INDESIT company

Model type:
T5

Commercial code:
F032244

RE0243T0 Exploded views

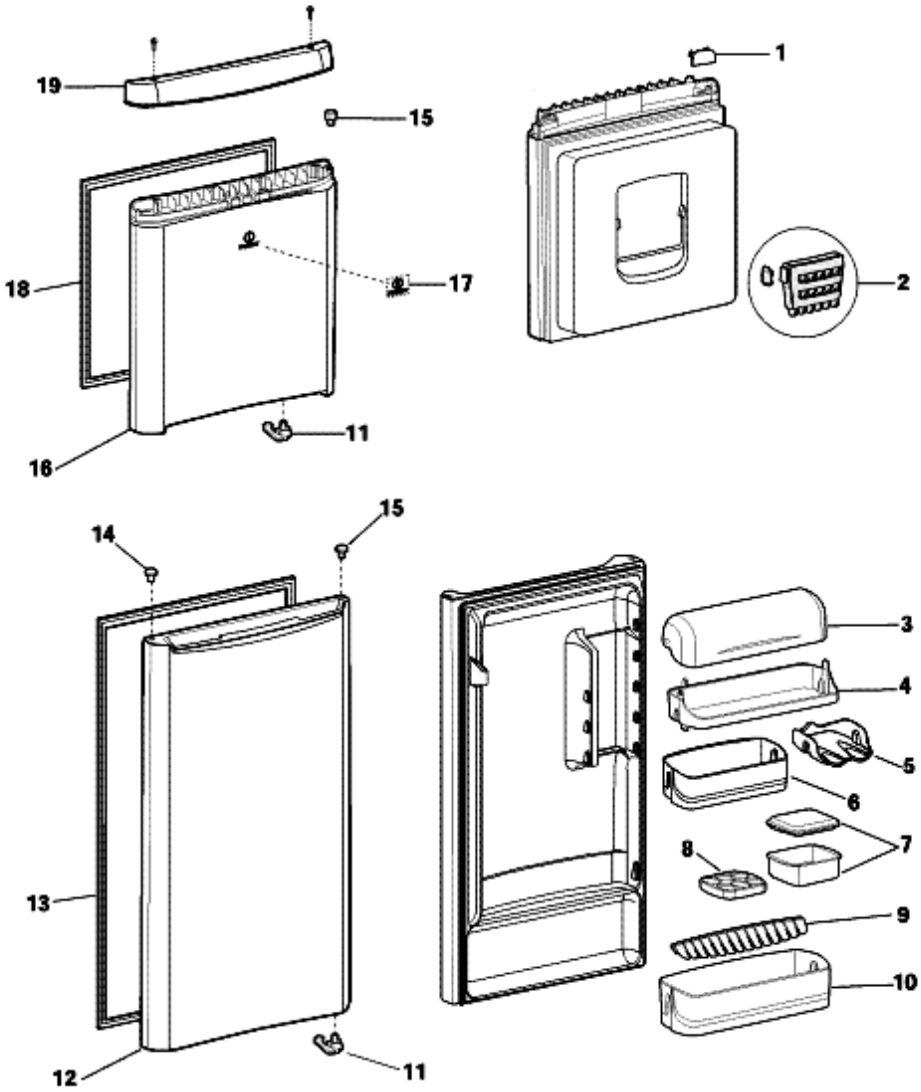
n2510e00: ELIMINATION OF ICE BOX INTEGRATED ON DOOR

From S/N 00218... on DD L70 models has been deleted ice box integrated in inner door and it has been substituted with door without integrated ice box plus added of "normal" ice box. At the end of stock will be managed only doors without integrated ice box.

SUBSTITUTED CODES ARE:

C00117948
C00098205
C00117771
C00110211

NEW CODES ARE:

C00196559
C00117027
C00252517
